Microcomputer Technical Information

IE-78K0S-NS-A In-Circuit Emulator for 78K0S Series Usage Restrictions		Document No.	ZBG-CD-05-0104	1/2
		Date issued	November 1, 2005	
		Issued by	Development Tool Group Multipurpose Microcomputer Systems Division 4th Systems Operations Unit NEC Electronics Corporation	
Related documents	IE-78K0S-NS-A User's Manual: U15207EJ1V0	Notification classification	√	Usage restriction
				Upgrade
				Document modification
				Other notification

IE-78K0S-NS-A In-Circuit Emulator for 78K0S Series - Usage Restrictions

Figure 2-1. Removal of Emulation Board Fixing Stays (Metal Fittings)

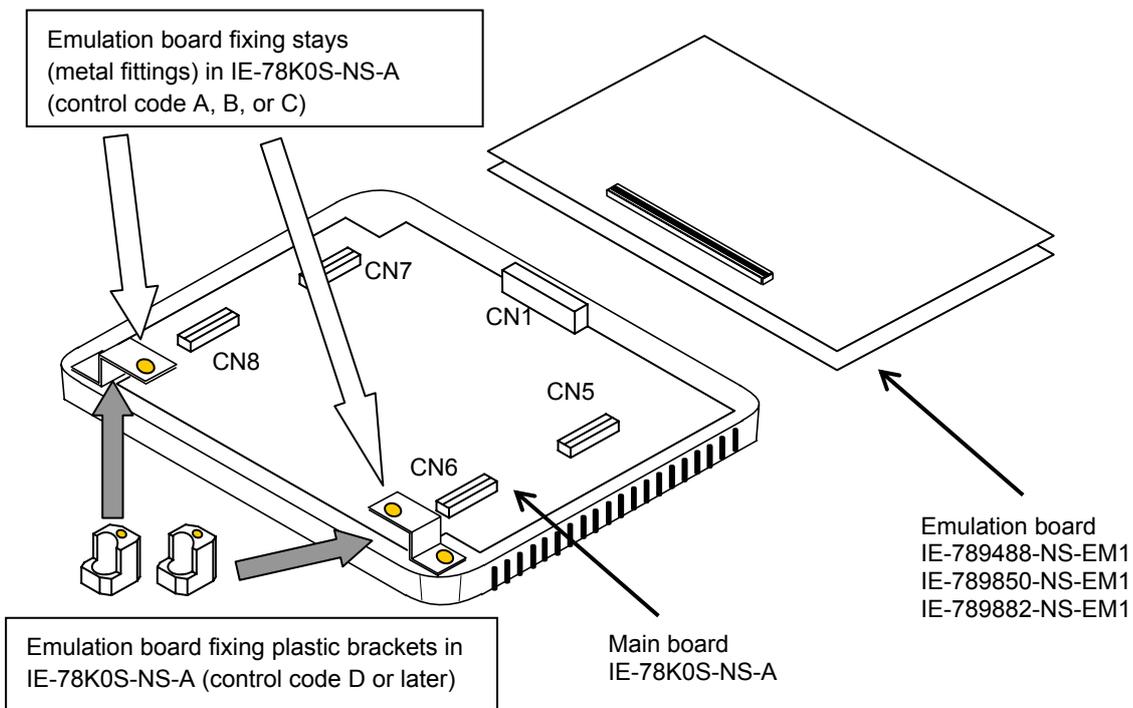
No. 2 Bug in contact between emulation board fixing stays (metal fittings) and emulation board test pin

When connecting the IE-789488-NS-EM1, IE-789850-NS-EM1, or IE-789882-NS-EM1 to the main board, the test pins of the emulation board contact the emulation board fixing stays (metal fittings).

As a temporary workaround, connect the emulation board after removing the IE-78K0-NS-A emulation board fixing stays (metal fittings). Figure 2-1 shows the positions of the stays.

The emulation boards will be revised by upgrading to the following versions (control code).

- IE-789488-NS-EM1: Control code C
- IE-789850-NS-EM1: Control code C
- IE-789882-NS-EM1: Control code B

The metal fittings have been replaced with the plastic brackets in IE-78K0S-NS-A control code D or later.
